Access Compliance Report

Public Rights-of-Way

(Curb Ramps)

Intersection ID: 31895	Main Street: SLALOM_HILL_RD	Cross Street: STOWE_DERBY_DR	Location:	N
ADA ID: BBA88D3C2518	Ramp Type: PerpDiag	Initial Pass/Fail: Fail	Overall Compliance: No	Severity Score: 10
Codes/Mitigation Info/Possible Solution		Field Measurements/Component Compliance

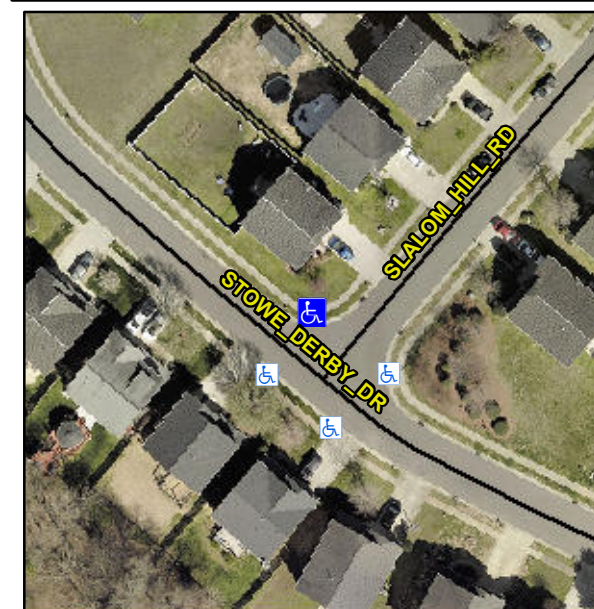
R304.5.1, R304.5.3

Compliance	Description	Data	Compliance	Description	Data
N/A	Ramp Length (in)	47.0	Yes	Ramp Slope (%)	6.7
No	Ramp Width (in)	41.0	No	Ramp XSlope (%)	3.5
N/A	Flare Type LT	N/A	N/A	Flare Type RT	N/A
N/A	Flare Slope LT (%)	N/A	N/A	Flare Slope RT (%)	N/A
N/A	Flare Traversable LT?	N/A	N/A	Flare Traversable RT?	N/A
N/A	Landing Length (in)	N/A	N/A	DWS Provided?	N/A
N/A	Landing Width (in)	N/A	N/A	DWS Contrast?	N/A
N/A	Landing Slope (%)	N/A	N/A	DWS Length (in)	N/A
N/A	Landing X Slope (%)	N/A	N/A	DWS Full Width?	N/A
N/A	Landing Curb? (Y/N)	N/A	N/A	DWS Offset (in)	N/A
N/A	Shared Landing?	N/A			
N/A	Gutter Ponding?	N/A	N/A	Gutter Slope (%)	N/A
N/A	Gutter Lip Ht (in)	N/A	N/A	Gutter X Slope (%)	N/A
N/A	Painted X Walk1?	No	N/A	Painted X Walk2?	No
	X Walk 1 Direction	To SW		X Walk 2 Direction	To SE
N/A	X Walk 1 Width (in)	N/A	N/A	X Walk 2 Width (in)	N/A
	X Walk 1 Slope (%)	2.8		X Walk 2 Slope (%)	2.3
	X Walk 1 X Slope (%)	1.4		X Walk 2 X Slope (%)	2.4

Remove & Replace Curb Ramp With Two New Directional Ramps or Equivalent.
